SUBJECT: 007999 – SR99 Bored Tunnel Alternative Design-Build Project
Federal-Aid No. BR-NH-STP-STPF-0099(111)
CO 172 – PCO 575, A.Way Restor-Const

**WASHINGTON STATE
DEPARTMENT OF TRANSPORTATION
CHANGE ORDER**

CONTRACT NO: 007999 FEDERAL AID NO: STP-ER-IM-0099 (11)
 CONTRACT TITLE: SR 99, BORED TUNNEL ALTERNATIVE - DESIGN BUILD PRO
 CHANGE ORDER NO: 172 PCO 575, A.WAY RESTOR-CONST

SR 99 TUNNEL PROJECT CONTRACT PACKAGE 14	SP254
STREET RESTORATION SITE PREPARATION PLAN	SHEET OF SHEETS

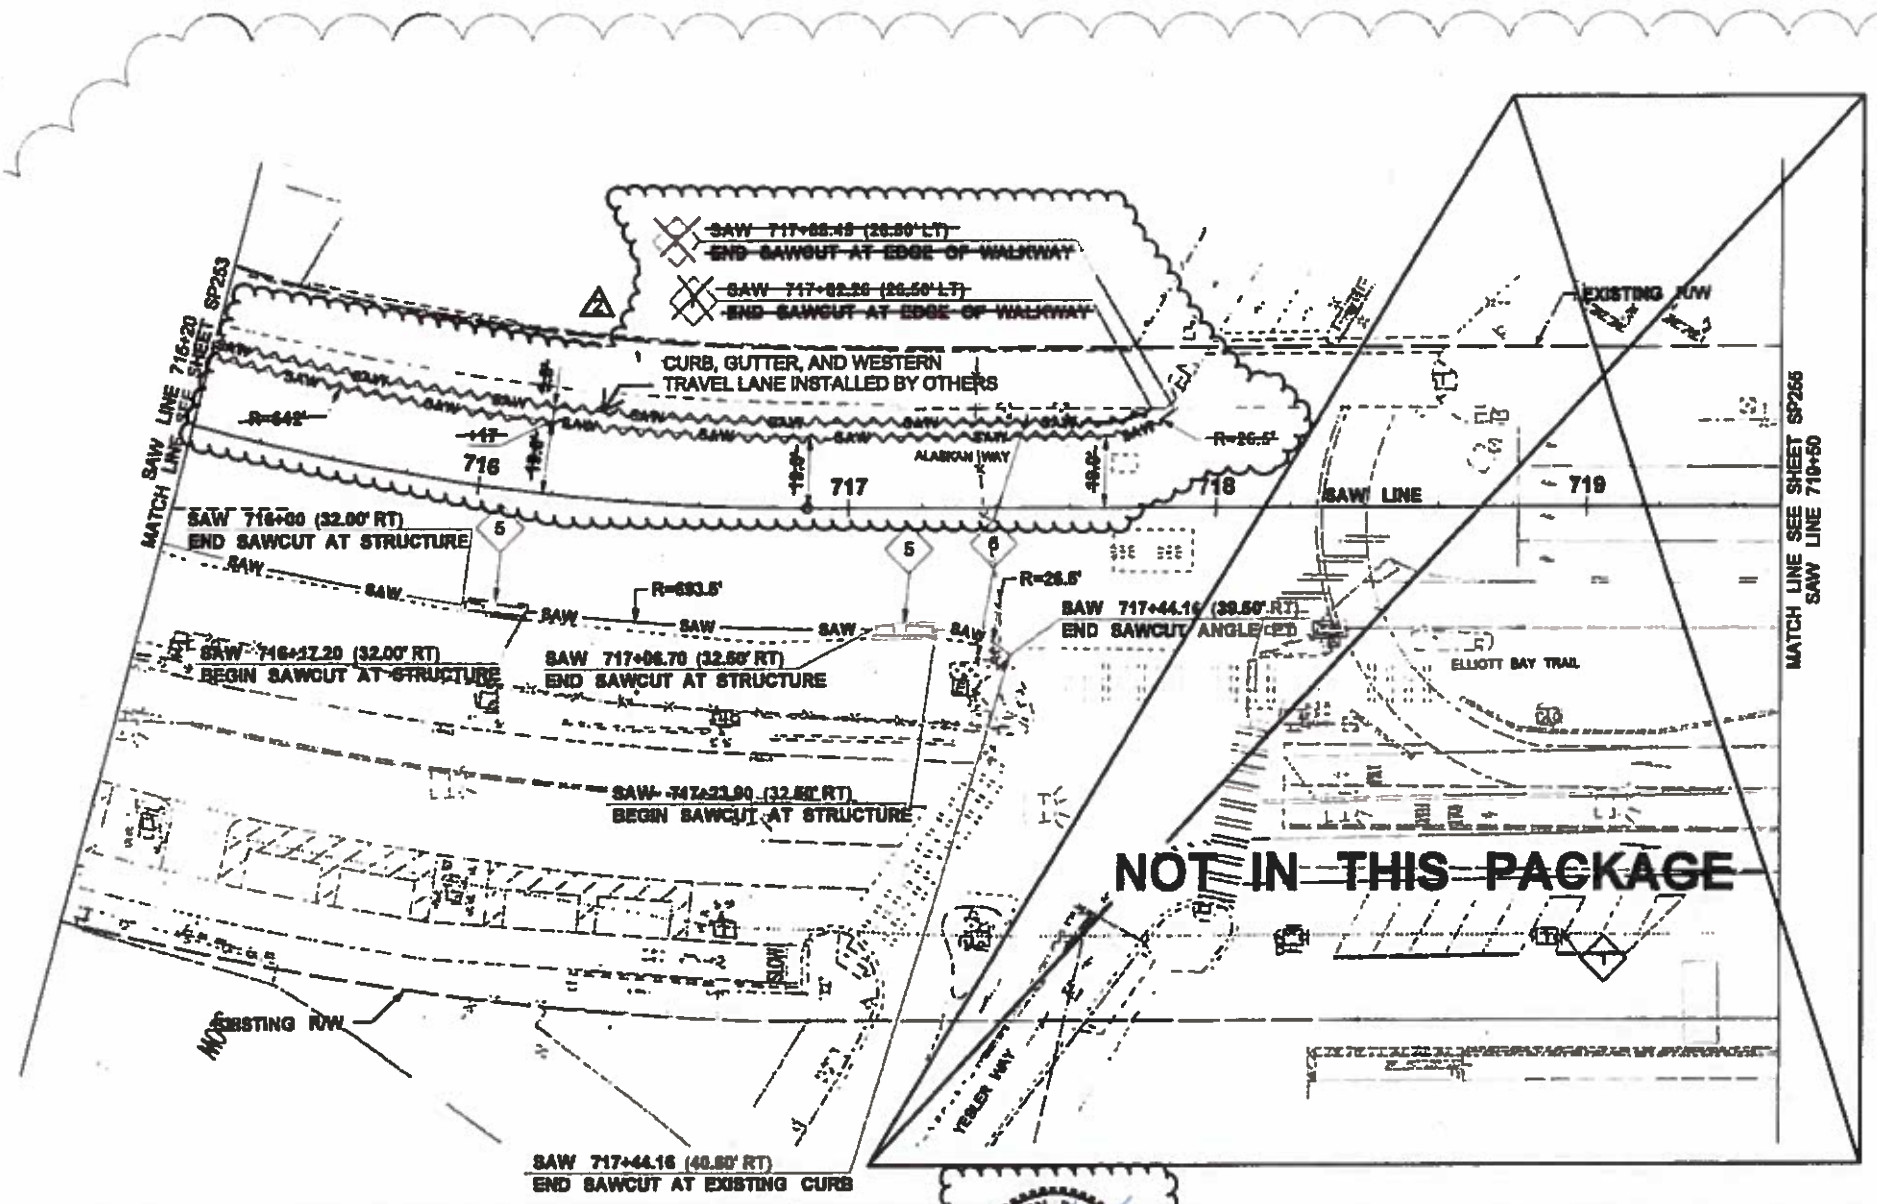
RFI 04147	01/05/2018	ST
NDC 085 - STREET RESTORATION MODIFICATIONS	04/06/2017	PC
REVISION	DATE	BY

CV362
SHEET
OF
SHEETS

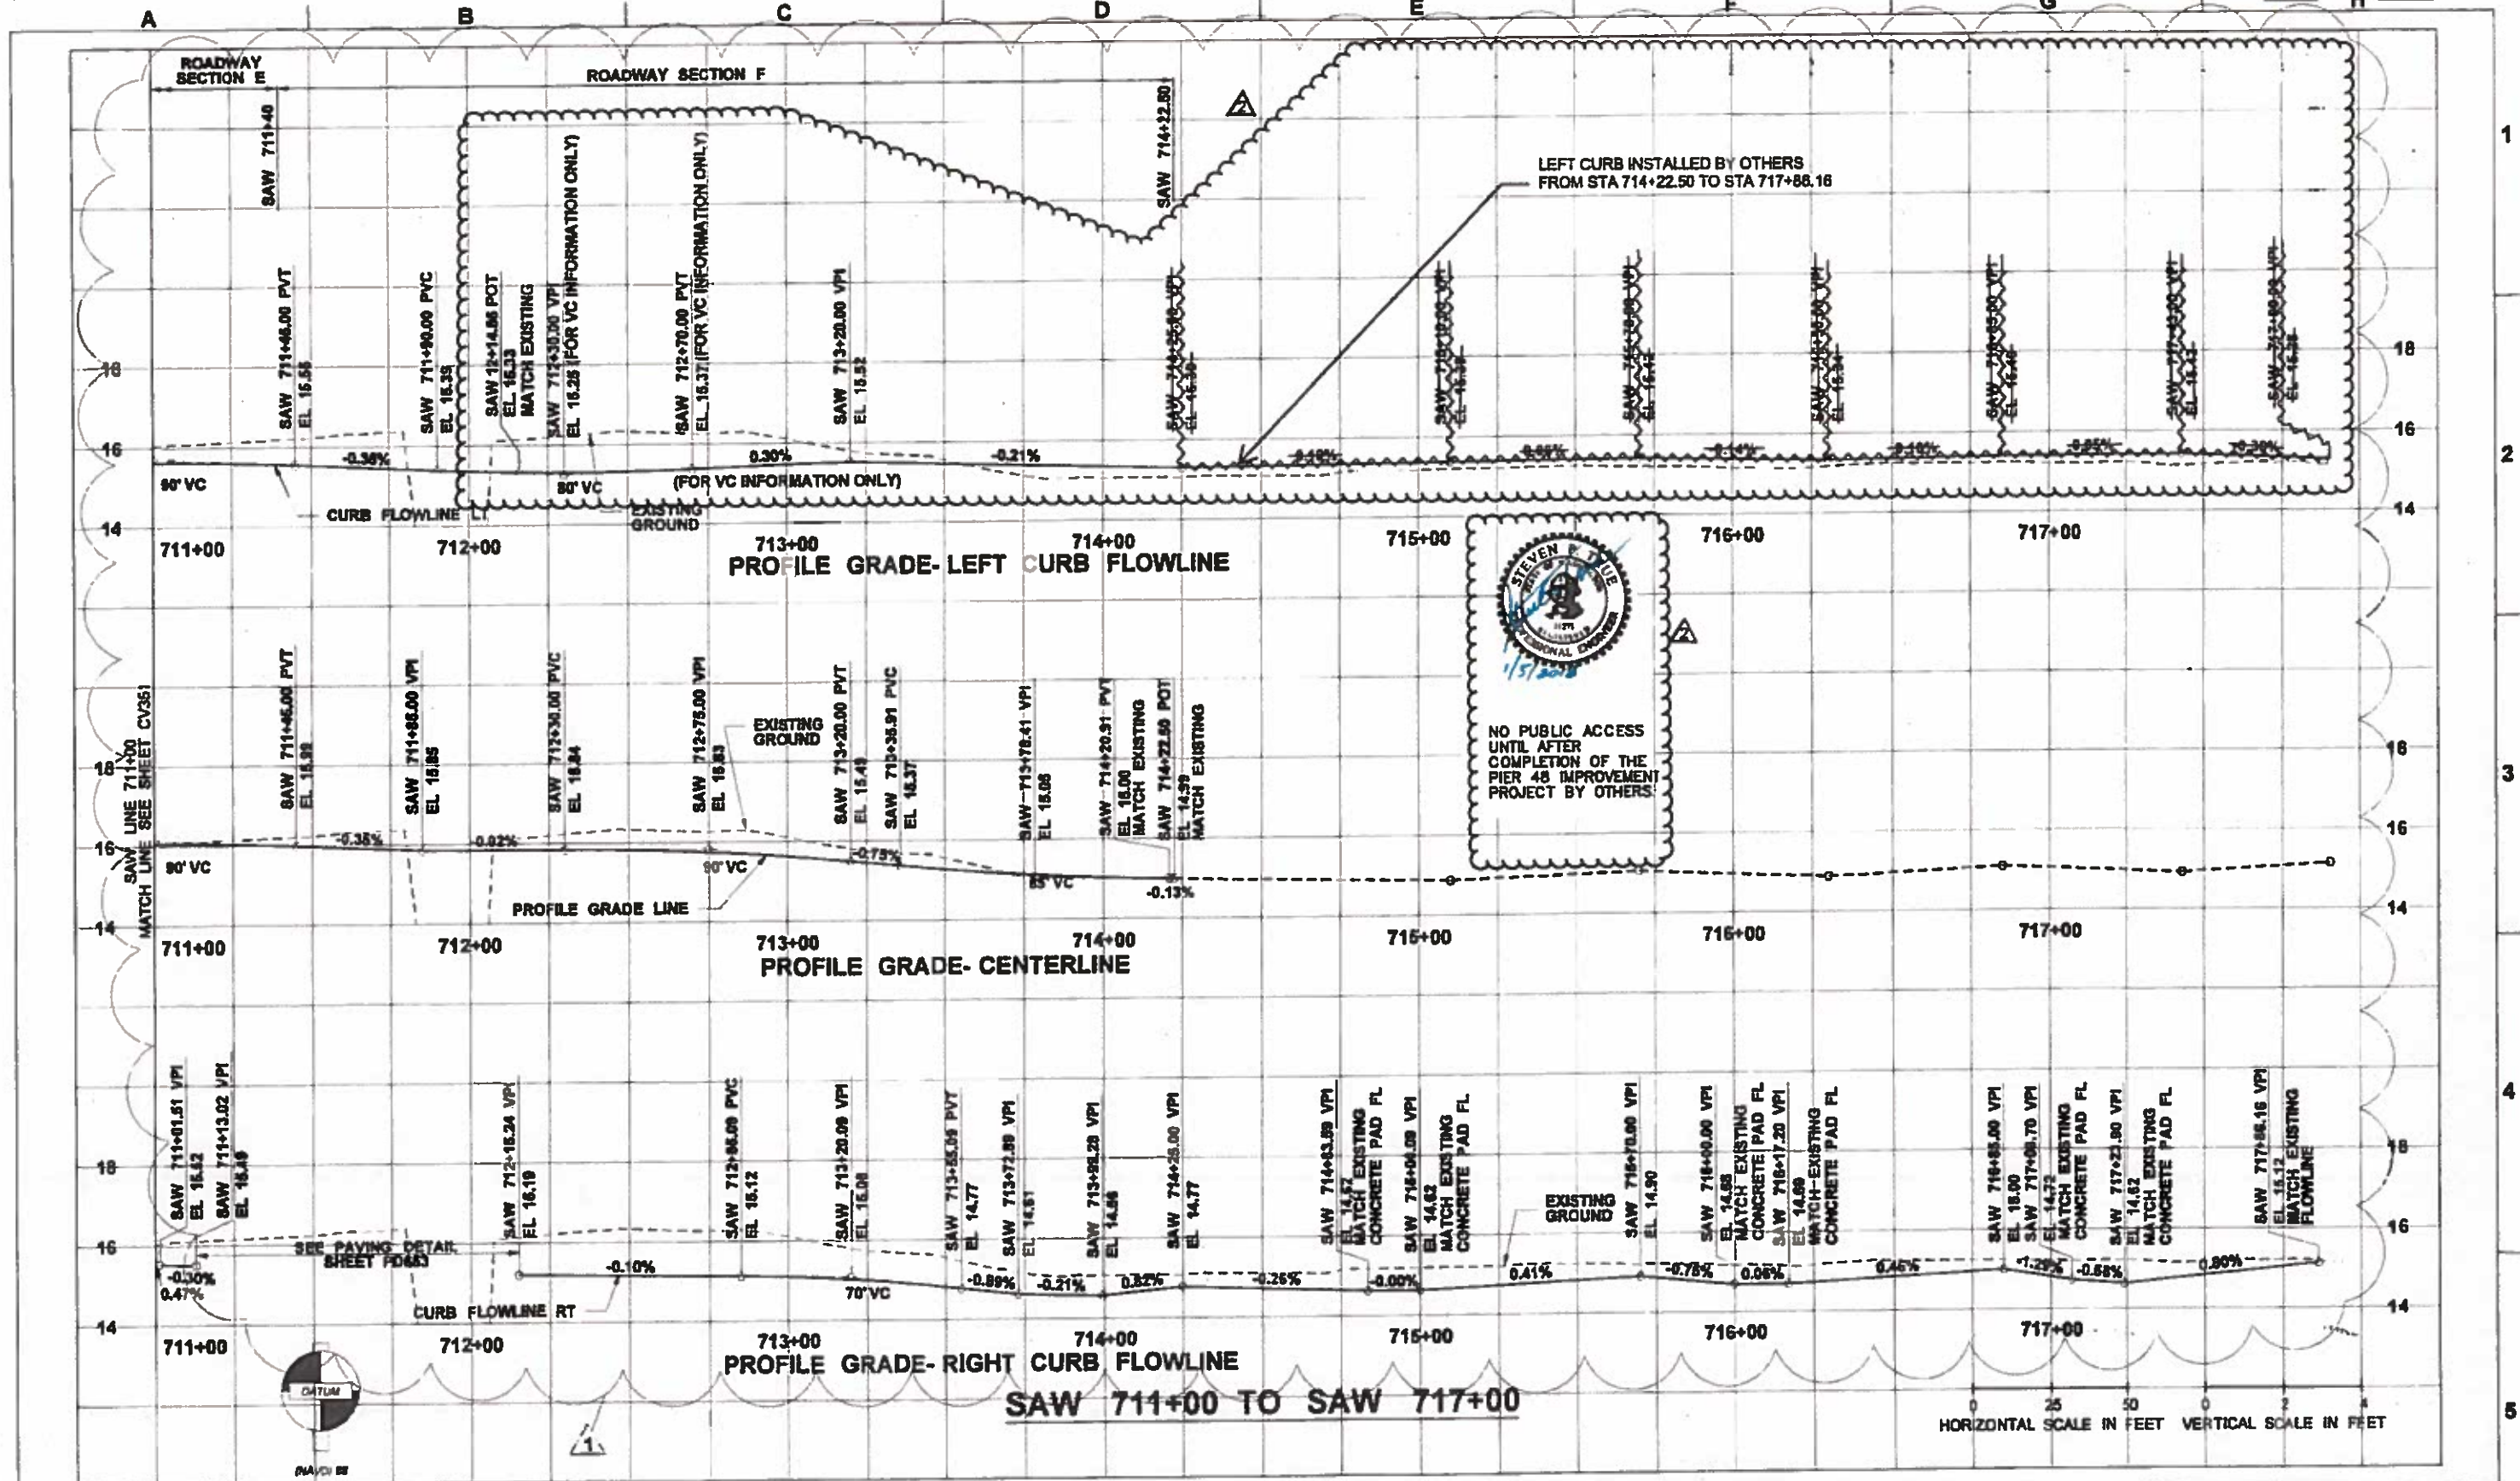
RFI 04147
1 NDC 098-STREET RESTORATION MODIFICATIONS
REVISION

IL152

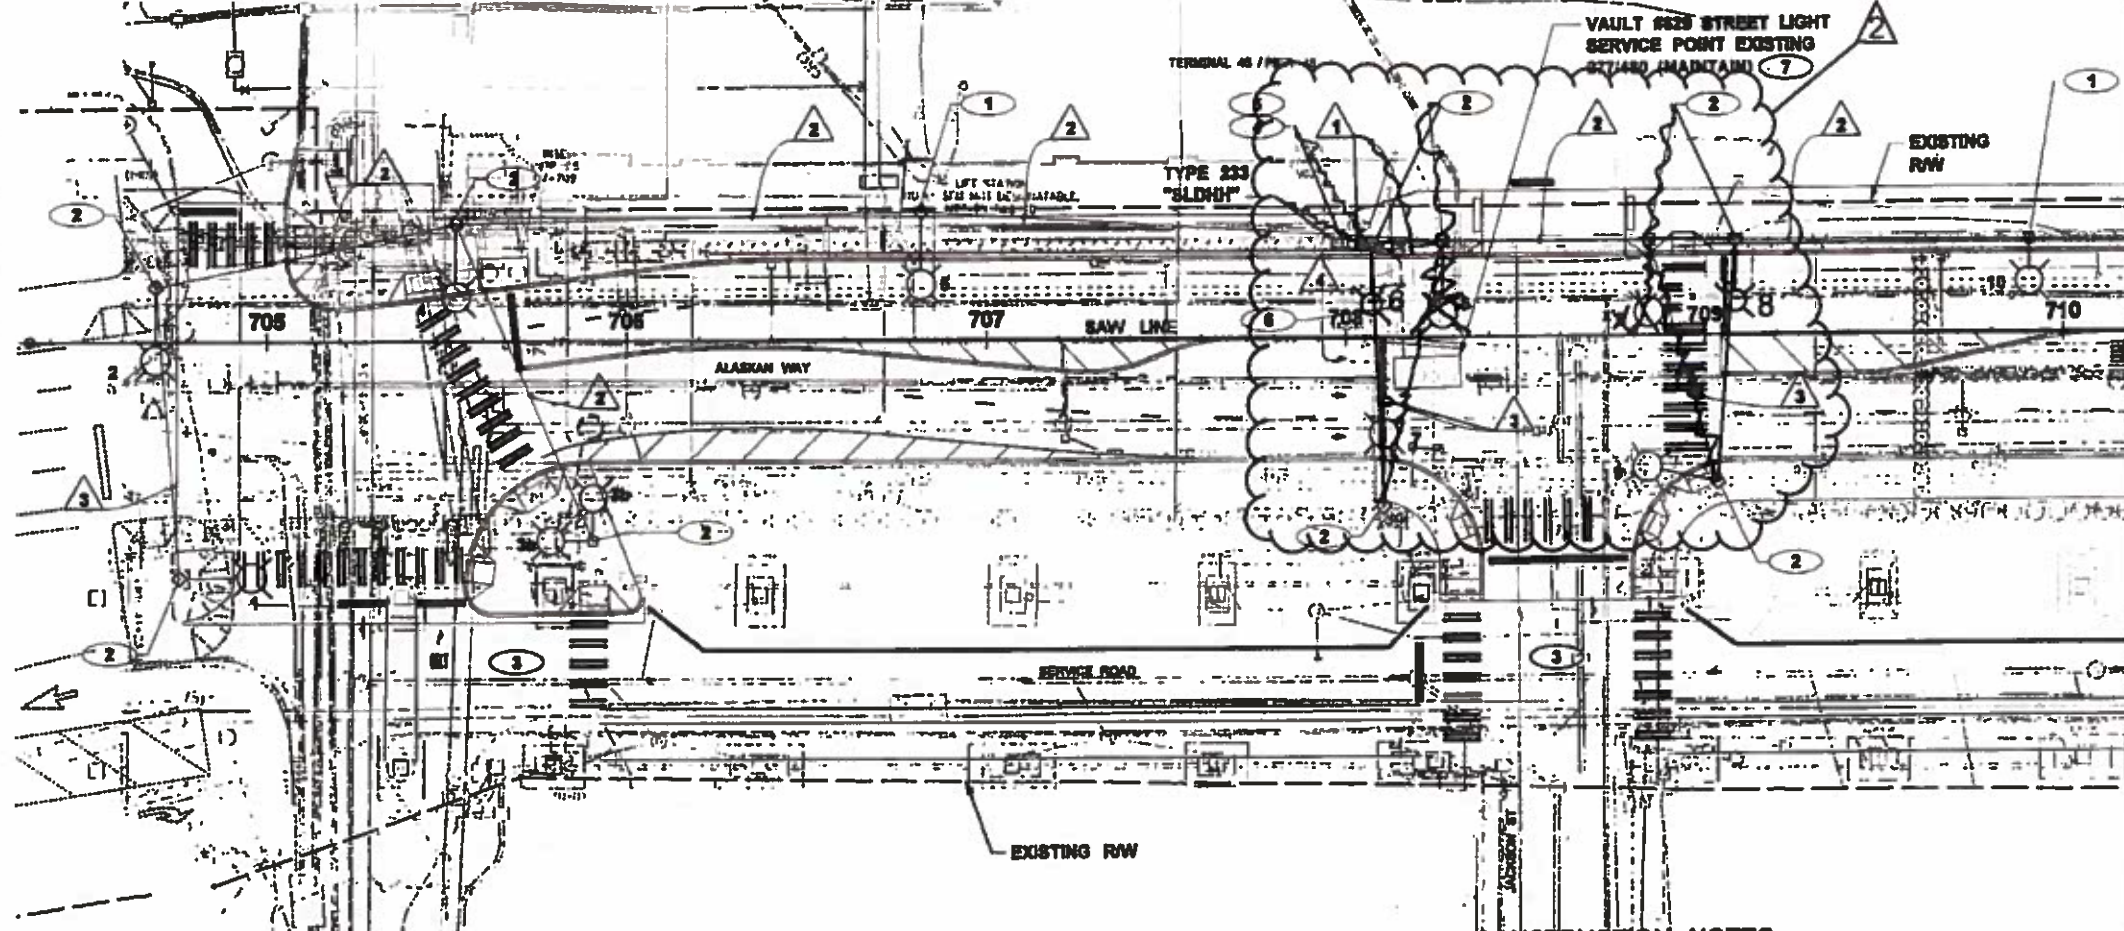
RFI 04147

NDC 088 - STREET RESTORATION MODIFICATIONS

SR 99 TUNNEL PROJECT CONTRACT PACKAGE 14	SG954
STREET RESTORATION INTERCONNECT PLAN	SHEET OF SHEETS

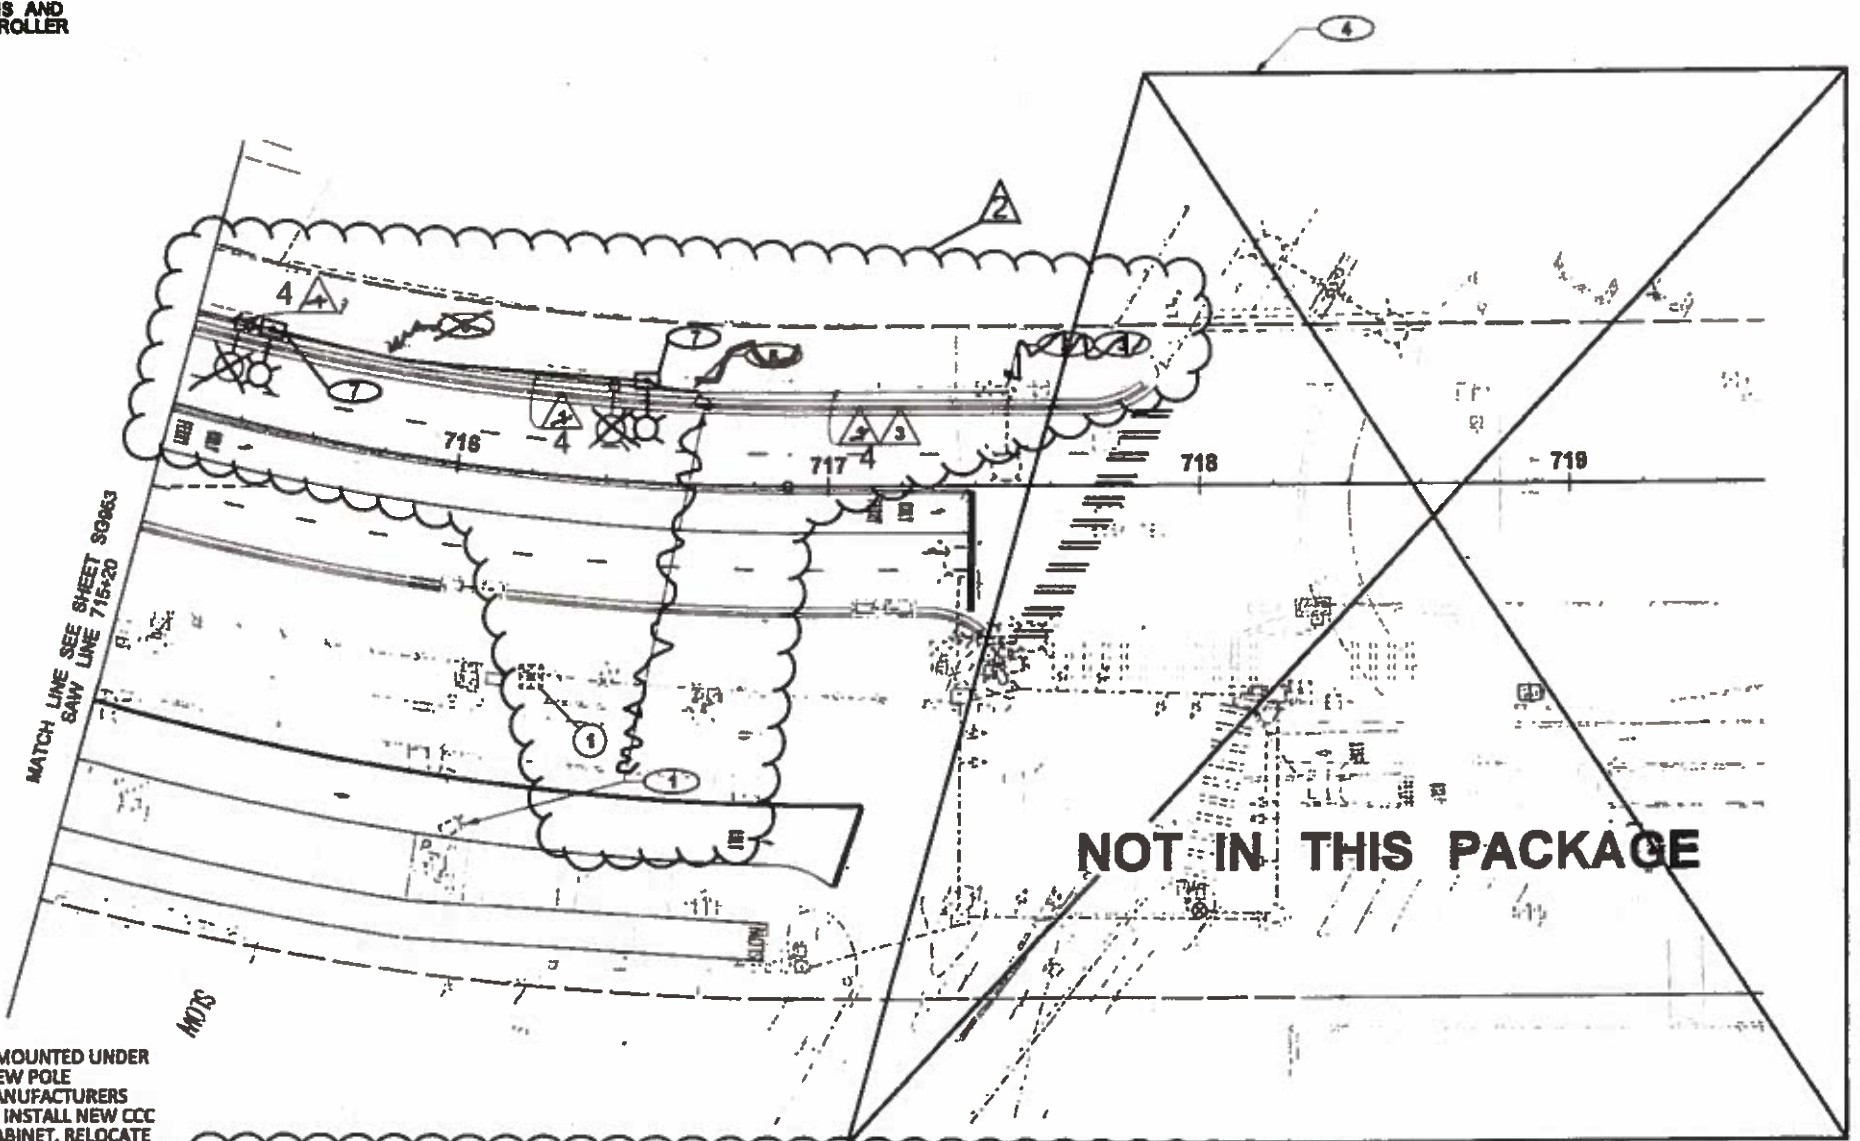
RFI-04147	01/09/2018	SZR
NDC 098 - STREET RESTORATION MODIFICATIONS	08/08/2017	JP
REVISION	DATE	BY
